- Request - Maumee River Overlay Review for Façade Renovations
- Location - 2520 & 2534 N. Summit Street
- Applicant + Owner - Kaiss Badwe  
2344 108th Street  
Toledo, OH 43611
- Architect - Duket Architects Planners  
830 N. Summit Street  
Toledo, OH 43604
- Attorney - Joanne Rubin  
316 N. Michigan Street, Suite 725  
Toledo, OH 43604

The staff recommends that the Toledo City Plan Commission recommend approval of MRO-2-24, a Maumee Riverfront Overlay Review for façade renovations at 2520 and 2534 N. Summit Street, to Toledo City Council for the following two (2) reasons:

MAUMEE RIVERFRONT OVERLAY REVIEW  
TOLEDO CITY PLAN COMMISSION  
REF: MRO-2-24  
DATE: July 11, 2024  
TIME: 2:00 P.M.

SUMMIT OIL CHANGE  
REMODEL

1 SITE PLAN  
A1.0 SCALE 1" = 20'

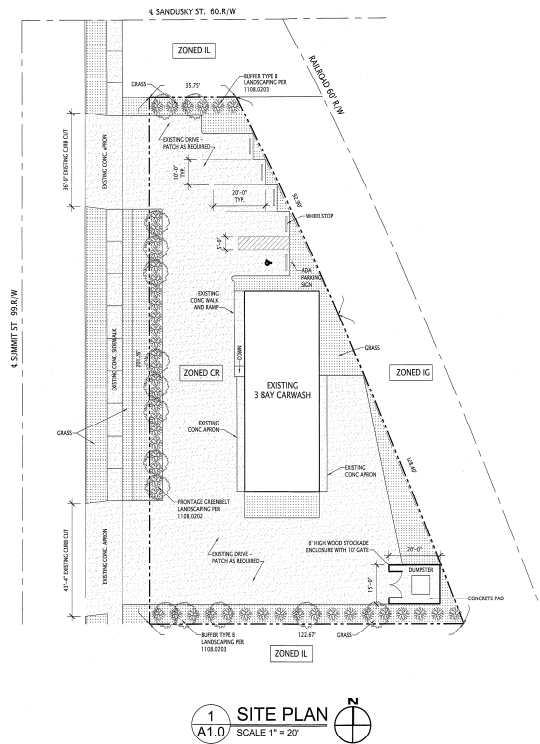
TMC§1108.0202 requires a fifteen-foot (15') greenbelt along public rights-of-way. At least one tree must be provided for every thirty feet (30') of lot frontage or fraction thereof. A fifteen-foot (15') frontage greenbelt buffer is required along N. Summit Street. The site plan submitted show eight (8) trees and a continuous shrub along N. Summit Street. **This is acceptable as depicted on site plan; however, applicant shall submit a landscape plan showing the details of proposed plants.**

Per TMC§1108.0203 – *Buffer and Screening Requirements*, a Type B Landscape Buffer is required at all CR Regional Commercial sites abutting Industrial Zoning Districts. The subject site abuts IL Limited Industrial to the north and south and IG General Industrial to the east. Hence, a Type B landscape Buffer is required. The Type B buffer shall be ten feet (10') in width and consist of four (4) canopy trees and fifteen (15) shrubs for every 100 linear feet. A fence six feet (6') to eight feet (8') in height may be substituted for the shrub requirements. The submitted site plan shows five (5) trees and eighteen (18) shrubs along the south property line. The north property line also shows two (2) trees and shrubs. **This is not acceptable as depicted. A revised landscape plan shall be submitted showing the required Type B landscape buffer along the east property line.**

2. Per TMC§1104.1601, a light equipment repair use requires a minimum of 1.5 parking spaces per a service bay. The elevation shows three (3) service bays; hence, 4.5 parking spaces are required. **The submitted site plan shows five (5) parking spaces. This is acceptable as depicted.**

3. One (1) van accessible parking space shall be required. The submitted site plan shows one accessible parking space included in the total number of parking spaces for the use. **Acceptable as depicted on site plan.**

- a. Per TMC§1108.0202, a fifteen-foot (15') frontage greenbelt shall be provided along N. Summit Street. At least one tree must be provided for every thirty feet (30') of lot frontage or fraction thereof. The submitted site plan shows eight (8) trees and a continuous shrub along N. Summit Street. **This is acceptable as depicted on site plan; however, applicant shall submit a landscape plan showing the details of proposed plants;**

- b. The subject site abuts IL Limited Industrial to the north and south and IG General Industrial east. Therefore, a Type B landscape Buffer is required. The Type B buffer shall be ten feet (10') in width and consist of four (4) canopy trees and fifteen (15) shrubs for every 100 linear feet. A fence six feet (6') to eight feet (8') in height may be substituted for the shrub requirements. The submitted site plan shows five (5) trees and eighteen (18) shrubs along the south property line. **This is not acceptable as depicted. A revised landscape plan shall be submitted showing the required Type B landscape buffer along the east property line;**

2 WEST ELEVATION  
A1.0 SCALE 1/8" = 1'-0"

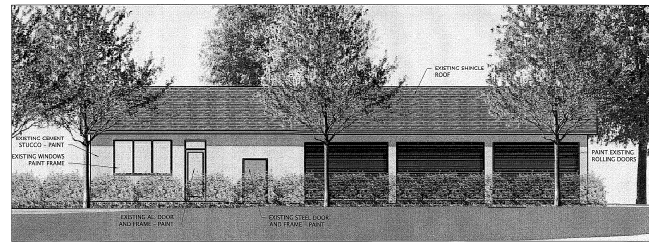
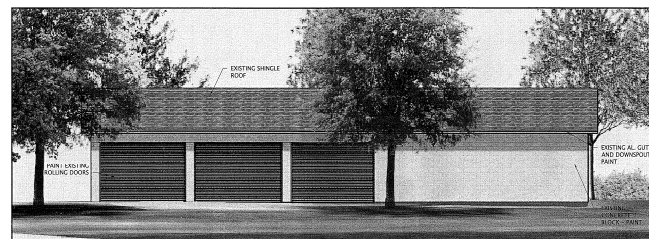
All proposed new buildings and renovations are subject to the commercial development standards under *TMC§1109.0200* and *TMC§1109.0500 – Façade Materials and Color*. The only changes proposed are the overhead doors to cover the existing open washing bays. **The proposed changes are acceptable as depicted.**

4. Building elevations are subject to TMC§1109.0400 – Building Façade Materials and Color. **Proposed elevations are acceptable as depicted.**
5. A detailed site, lighting, fencing and four (4) copies of a landscaping plan (separate from building & site plans) shall be submitted to the Plan Director for review and approval. Such plan shall include:
